STRUCTURAL CALCULATIONS

GLASS RESIDENCE
Retaining Wall Adjacent to East Foundation Wall

3333 Q Street NW
Washington, DC

RSA PROJECT NO. W2714
NOVEMBER 26, 2011

40'-5"±
WALL TYPE B

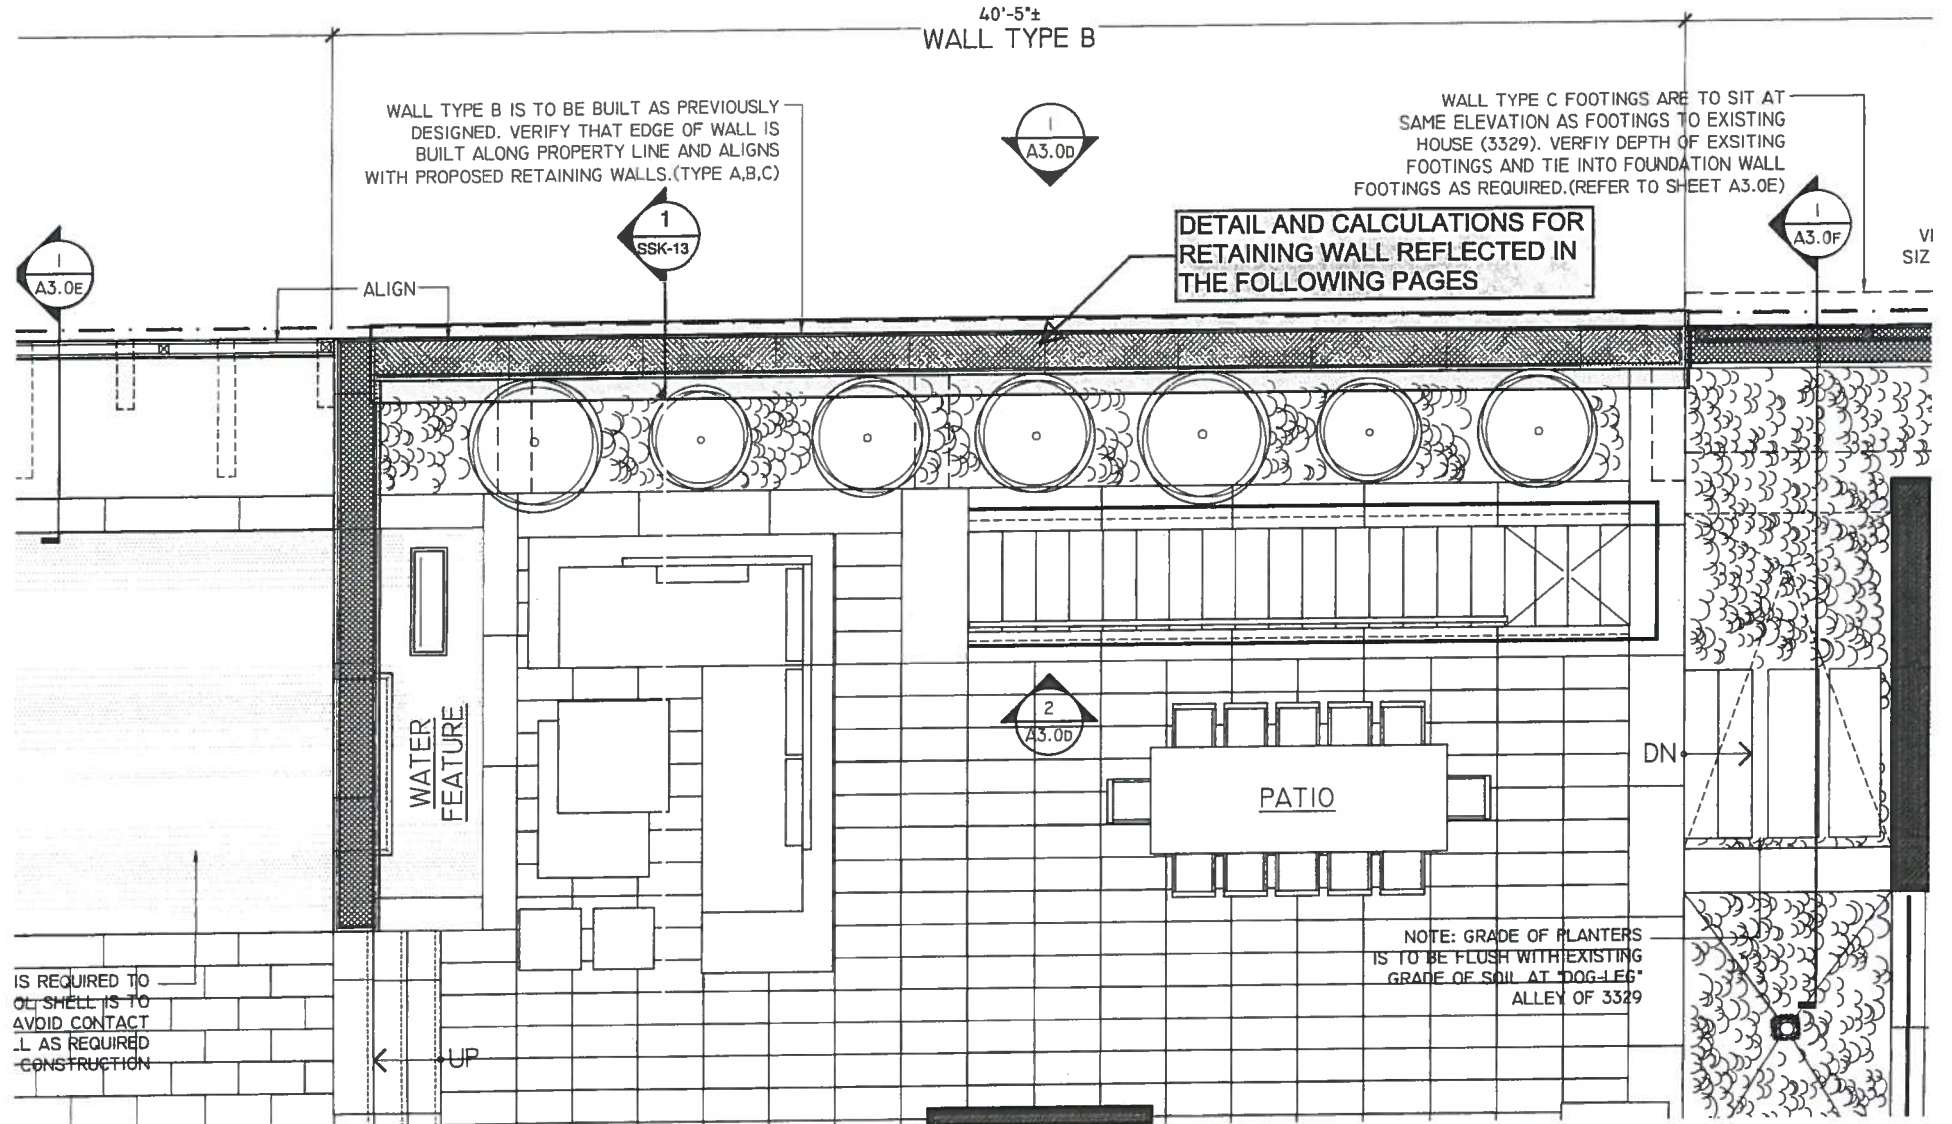
WALL TYPE B IS TO BE BUILT AS PREVIOUSLY
DESIGNED. VERIFY THAT EDGE OF WALL IS
BUILT ALONG PROPERTY LINE AND ALIGNS
WITH PROPOSED RETAINING WALLS. (TYPE A,B,C)

WALL TYPE C FOOTINGS ARE TO SIT AT
SAME ELEVATION AS FOOTINGS TO EXISTING
HOUSE (3329). VERIFY DEPTH OF EXISTING
FOOTINGS AND TIE INTO FOUNDATION WALL
FOOTINGS AS REQUIRED. (REFER TO SHEET A3.0E)

RETAINING WALL SECTION

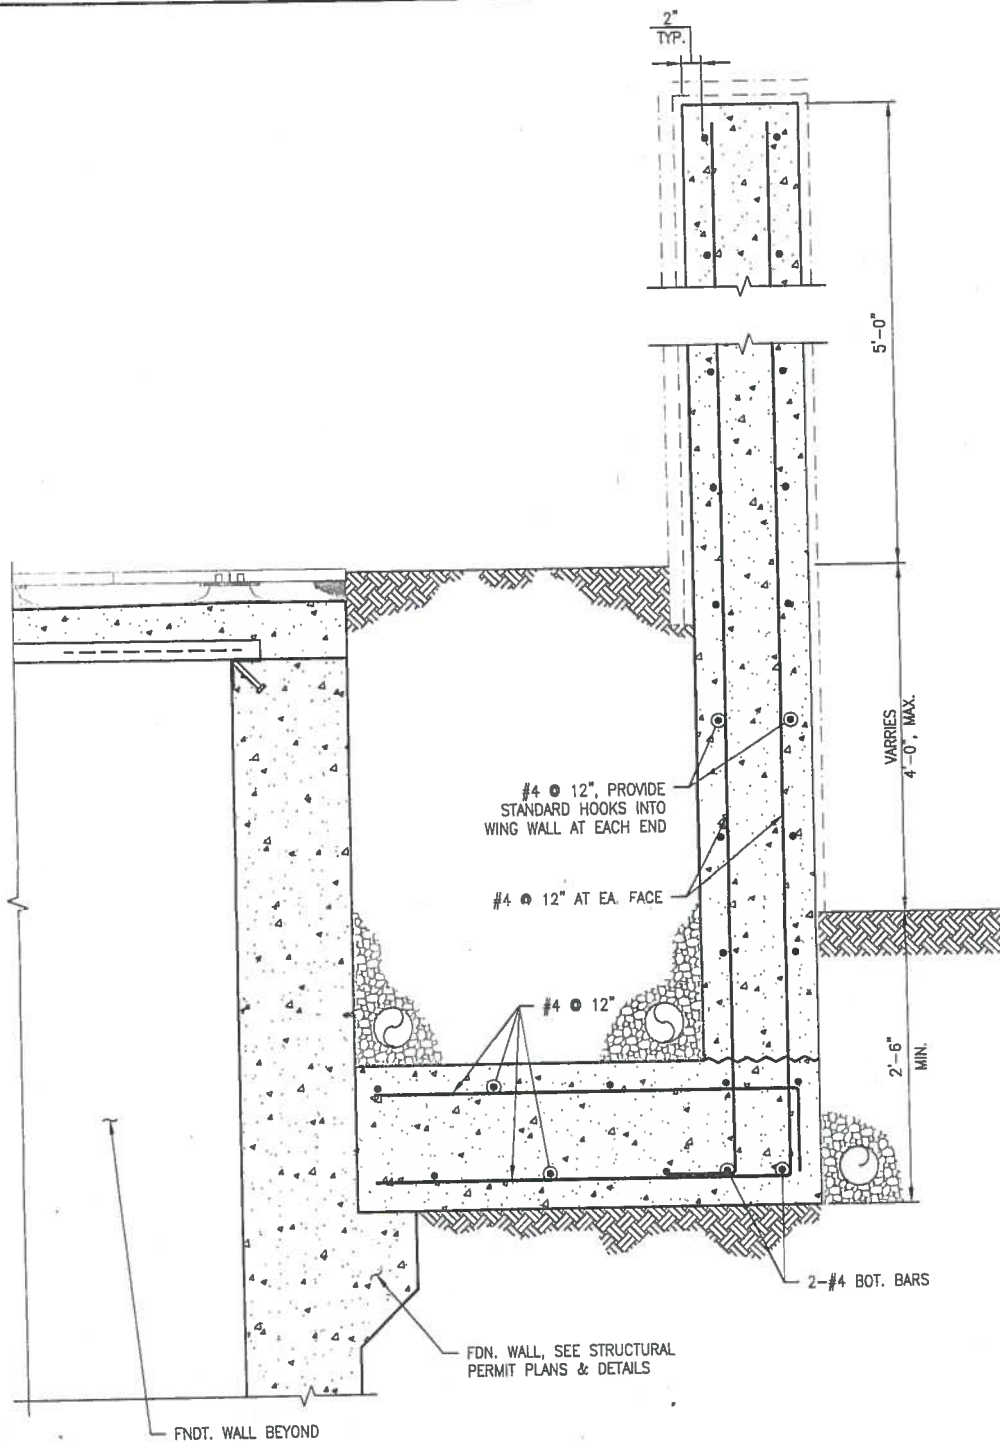
- SEE ARCHITECTURAL PLANS FOR DRAINAGE
- DETAIL IS A REVISION TO DETAIL 6/S2.9 FROM DECEMBER 6, 2011 STRUCTURAL PERMIT PLANS.
